## Economic and Social Council

### **Proposal for Supplement 4 to the 07 series of amendments to Regulation No. 14 (Safety-belt anchorages)**

#### **Submitted by the Working Party on Passive Safety \***

The text reproduced below was adopted by the Working Party on Passive Safety (GRSP) at its fiftieth session to align UN Regulation No. 14 with the provisions of draft Regulation on Child Restraint Systems (CRS). It is based on document ECE/TRANS/WP.29/GRSP/2011/22, not amended (ECE/TRANS/WP.29/GRSP/50, para. 20). It is submitted to the World Forum for Harmonization of Vehicle Regulations (WP.29) and to the Administrative Committee (AC.1) for consideration.

Figure 1  
3D view of the support leg foot assessment volume

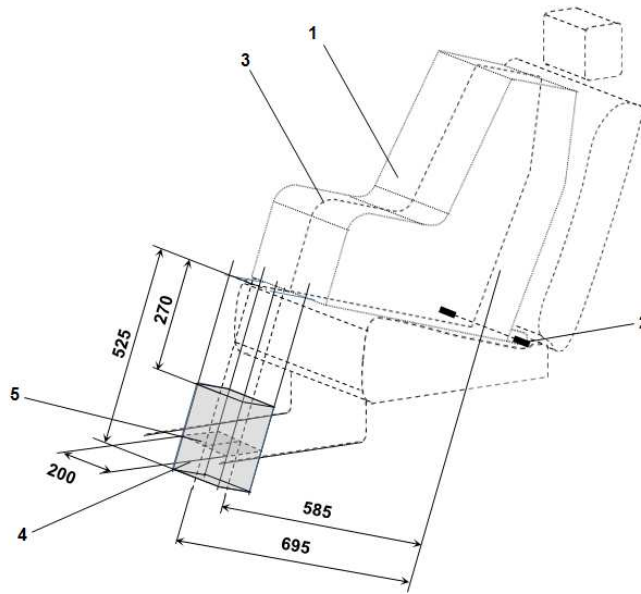
In addition to the requirements defined in 5.2.3. and 5.2.4. it shall be verified that the upper surface of the vehicle floor (incl. trim, carpet, foam, etc.) intersects with both of the limiting surfaces in the x- and y-directions of the support leg foot assessment volume, as shown in figures 1 and 2 of Annex 10 of this Regulation.

The support leg foot assessment volume is characterized as follows (see also annex 10, figure 1 and 2 of this Regulation):

- (a) In width, by the two planes parallel to and 100 mm apart from the median longitudinal plane of the child restraint fixture installed in the respective seating position; and
- (b) In length, by the two planes perpendicular to the plane given by the child restraint fixture bottom surface and perpendicular to the median longitudinal plane of the child restraint fixture, 585mm and 695 mm apart from the plane passing through the centerlines of the ISOFIX lower anchorages and being perpendicular to the CRF bottom surface; and
- (c) In height, by two planes which are parallel to and 270 mm and 525 mm below the child restraint bottom surface.

Insert a new Annex 10, to read:

**Example for a modified Static force application device with support leg test probe (SFAD<sub>SL</sub>) showing the required adjustment range and dimensions of the support leg foot**

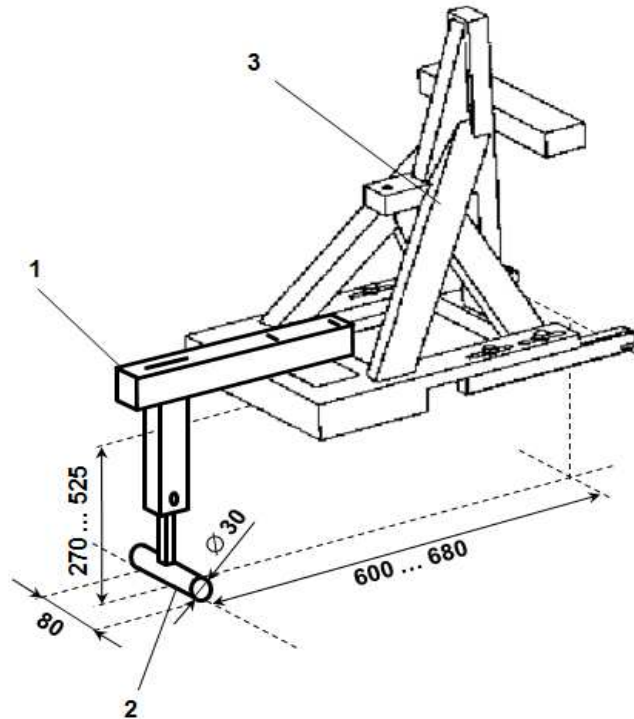
- "2.22. "Static force application device (SFAD)" means a test fixture that engages the vehicle ISOFIX anchorages systems and that is used to verify their strength and the ability of the vehicle or seat structure to limit the rotation in a static test. The test fixture for lower anchorages and top tethers is described in the figures 1 and 2 annex 9, as well as an SFAD<sub>SL</sub> (Support Leg) to assess i-Size seating positions with regard to the vehicle floor strength. An example for such an SFAD<sub>SL</sub> is given in Figure 3 of Annex 10."

In addition to the tests specified in paragraphs 6.6.4.3. and 6.6.4.4., a test with a modified static force application device, which consists of a SFAD and includes a support leg test probe as defined in figure 3 of annex 10, shall be performed. The support leg test device shall be adjusted in length and width to assess the vehicle floor contact surface, as defined in paragraph 5.2.5.2. (see also figures 1 and 2 of Annex 10 of this Regulation). The height of the support leg test device shall be adjusted in a way that the foot of the support leg test device is in contact with the upper surface of the vehicle floor. In case of incremental height adjustment, the first notch where the foot rests stable on the floor shall be chosen; in case of a non-incremental/continuous adjustment of the support leg test device height, the pitch angle of the SFAD shall be increased by 1.5 +/- 0.5 degrees due to the height adjustment of the support leg test device.

The horizontal excursion (after pre-load) of point X of the SFAD during application of the 8 kN ± 0.25 kN force shall be limited to 125 mm and permanent deformation including partial rupture or breakage of any ISOFIX low anchorage and the vehicle floor contact surface, or surrounding area shall not constitute failure if the required force is sustained for the specified time."

Figure 4  
Symbol used to identify an i-Size seating position

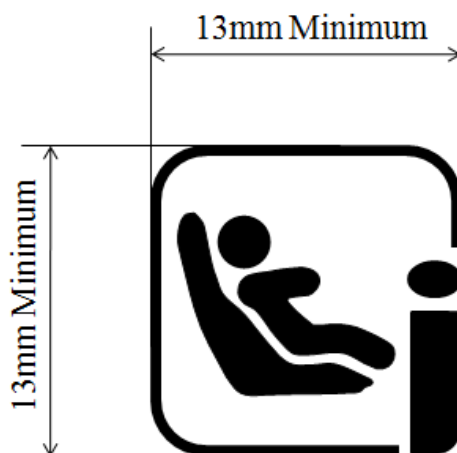
Each i-Size seating position shall be permanently marked adjacent to the ISOFIX low anchorages system (bar or guidance device) of the respective seating position.

The minimum marking shall be the symbol of Annex 10, figure 4 consisting of a square with a minimum size of 13 mm and containing a pictogram and meeting the following conditions:

- (a) the pictogram shall contrast with the background of the square;
- (b) the pictogram shall be located close to each bar of the system.
